Modification or Addition to Improvement Standards and Details

Modification Number: **2013-01**

Effective Date: August 2, 2013

DRAWING NUMBER
SL - 4

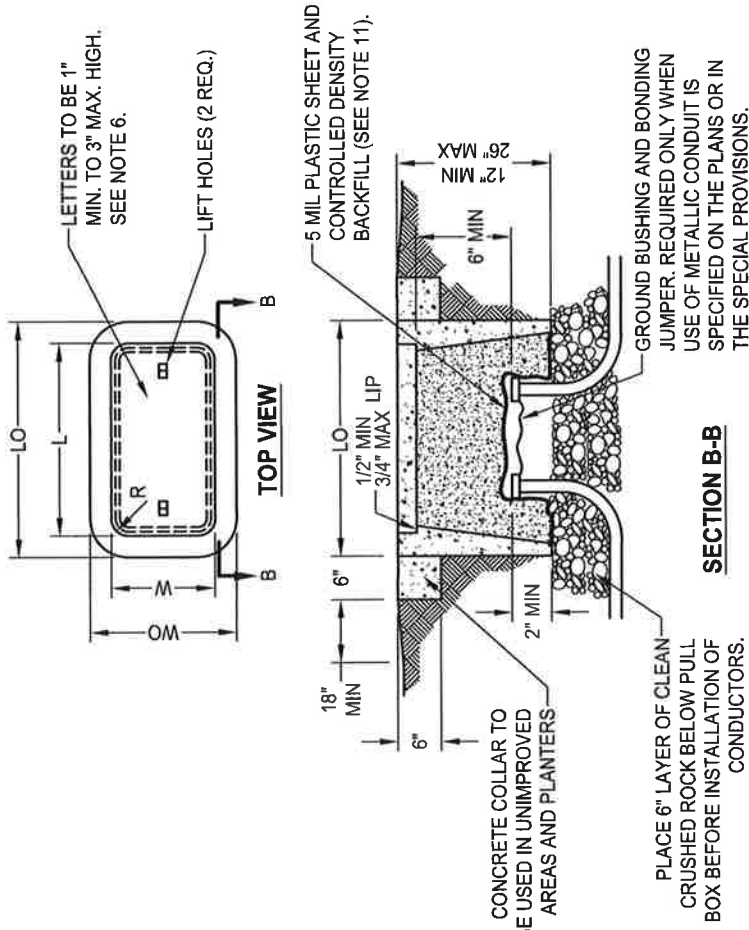
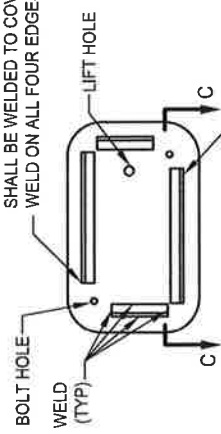
1. Amend Standard Drawing Nos. SL-4 and SL-5 to include provisions for filling in the pull boxes with controlled density backfill. The amended standard drawings are attached. Projects with preconstruction meetings prior to effective date are not subject to this modification.

- STEEL REINFORCING SHALL BE A REGULARLY USED IN THE STANDARD PRODUCTS OF THE RESPECTIVE MANUFACTURER.
 - PULL BOXES FOR STREET LIGHTING, UPON COMPLETION OF BURN TEST, SHALL BE FILLED WITH CONTROLLED DENSITY BACKFILL, PER CITY OF ELK GROVE CONSTRUCTION SPECIFICATIONS SECTION 50-15. A 5 MIL PLASTIC SHEET SHALL COVER THE CONDUITS/WIRES PRIOR TO POURING OF BACKFILL TO A DEPTH OF TWO (2) INCHES OVER THE CONDUITS.
